Reference 19/0620/MOUT

Location Cranbrook Expansion Zone West Large Site Station Road Broadclyst

Proposal Outline planning application with all matters reserved except access to the existing highway network for the expansion of Cranbrook comprising up to 870 residential dwellings; C2 residential institutions; one primary school (Use Class F1) with early years provision (Class F1/E); mixed use area including Use Classes C3 (Residential), E (Commercial Business and Service Uses), F1 (Learning and Non-residential institutions), F2 (Local Community Uses), and Sui Generis (hot food takeaways, pubs/bars) (Class E and Sui Generis uses to comprise up to 1,500 sq metres gross); recreation facilities and children's play; green infrastructure (including open space and Suitable Alternative Natural Greenspace (SANGS)); access from former A30, Station Road and Burrough Fields and crossings; landscaping; allotments; engineering (including ground modelling and drainage) works; demolition; associated infrastructure; and car parking for all uses.

RECOMMENDATION:

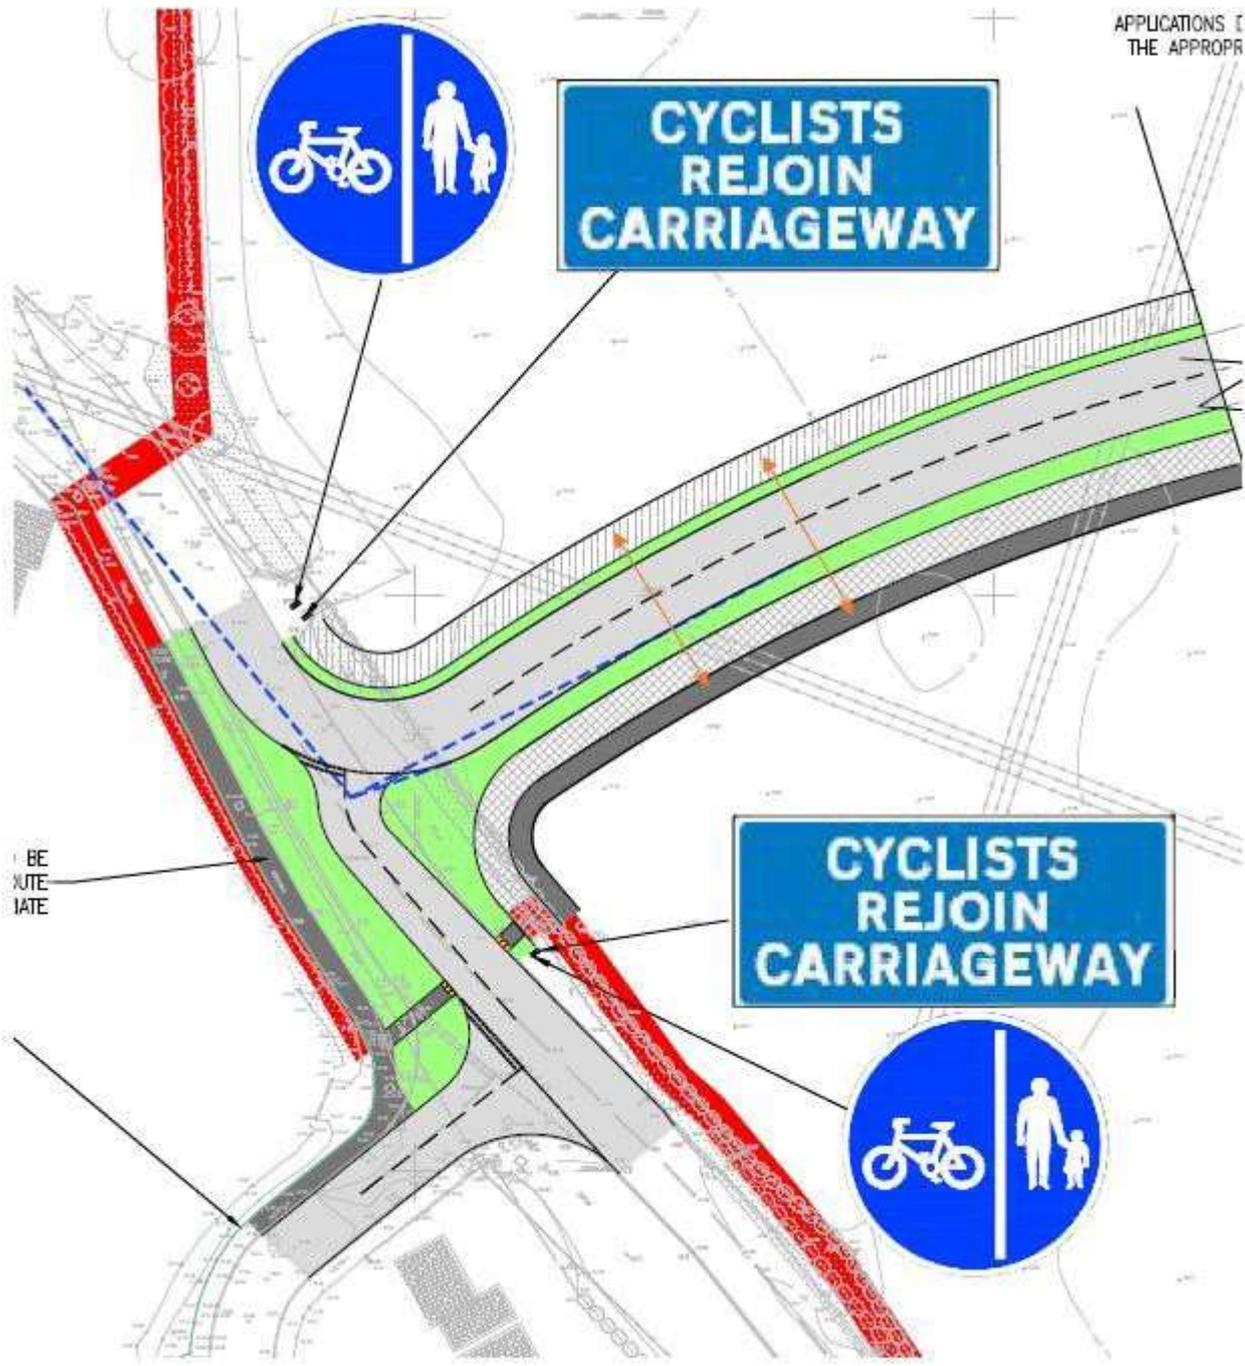
Some of the off-site works indicated in the documents are not actually proposed to be brought forward by this development, such as the bridge and traffic signals on Station Road (noting the Inspectors interim comments on the bridge). The funding of these elements of the IDP will need to be supported by this development and should feature in the s106 negotiations.

The WSP submission addresses the remainder of the DCC queries to the extent that I am happy that the highway authority objection to the proposals can now be withdrawn.

A drawing below has been provided to highlight the areas in question to help avoid confusion.

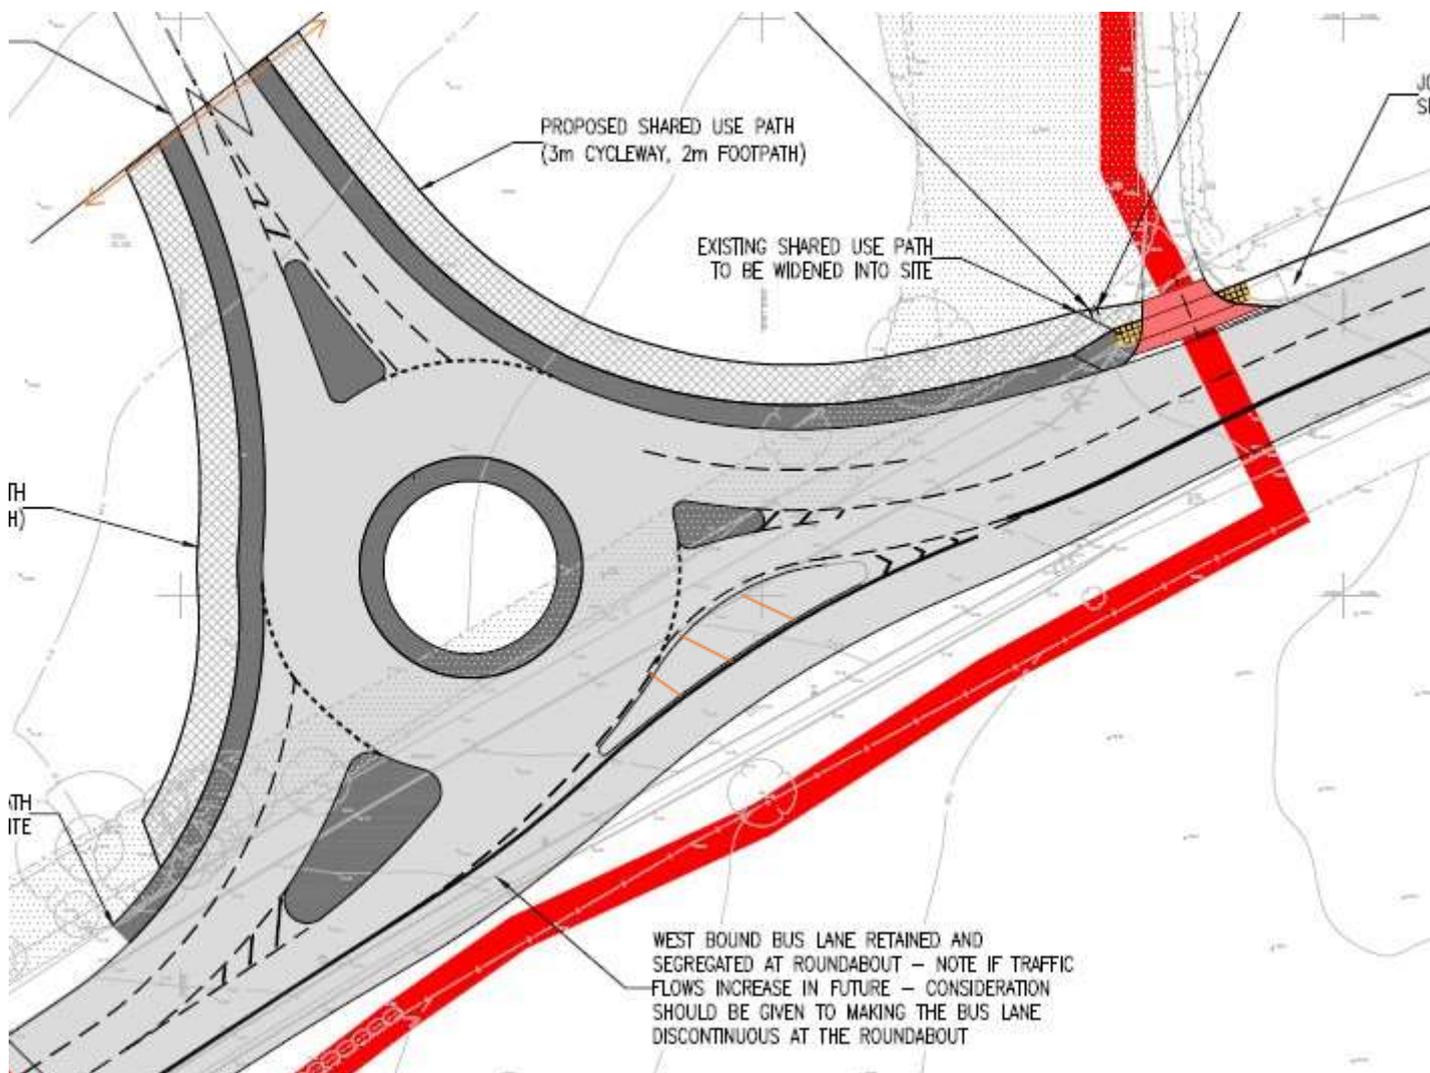
lines for footfall travelling along London Road and likely encourage NMUs informally crossing on the new spur. Therefore, a controlled crossing arrangement, (detailed design of which can be agreed at the latter stages), needs to be located further south around the northern extremities of the coloured layout (as recommended in a previous email).

For avoidance of doubt going forward, the Highway Authority would also like clarity on the proposed island arrangement at the south-eastern edge of the roundabout proposed that separates the bus lane and vehicle lane. This would need to be designed in a way that will ensure vehicle activity over this area will not occur and that all vehicles navigating around/across the roundabout will not deviate from the driving lanes.

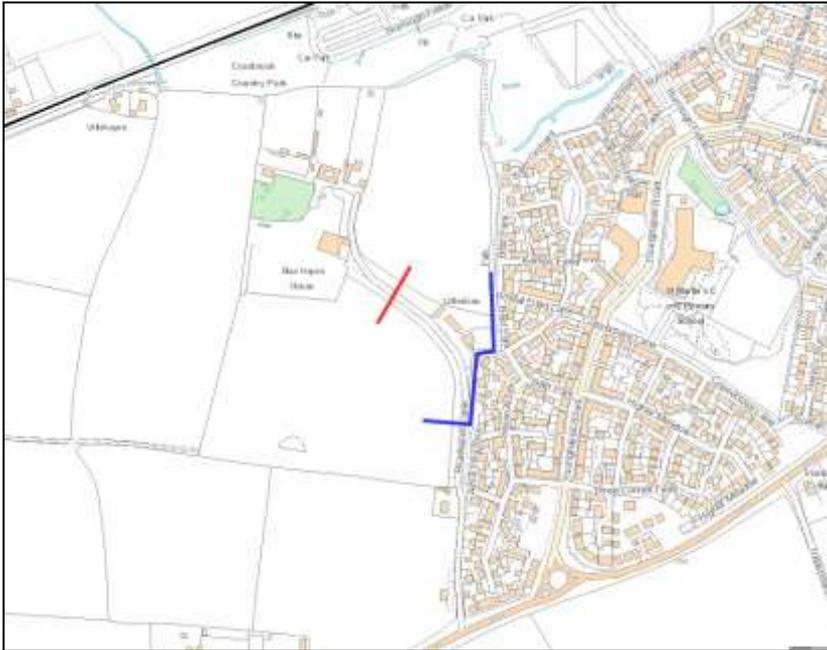
I can only find a single drawing 10292 which is apparently a 'drainage strategy' but which is clearly inadequate on its own. What is the rationale for several attenuation basins all confined to the edge of development? Cranbrook masterplan calls for a single large attenuation basin which can be designed to maximise biodiversity. The example below is from the nearby Saxon Brook development by Redrow and shows the sort of outcome that can and should be achieved.
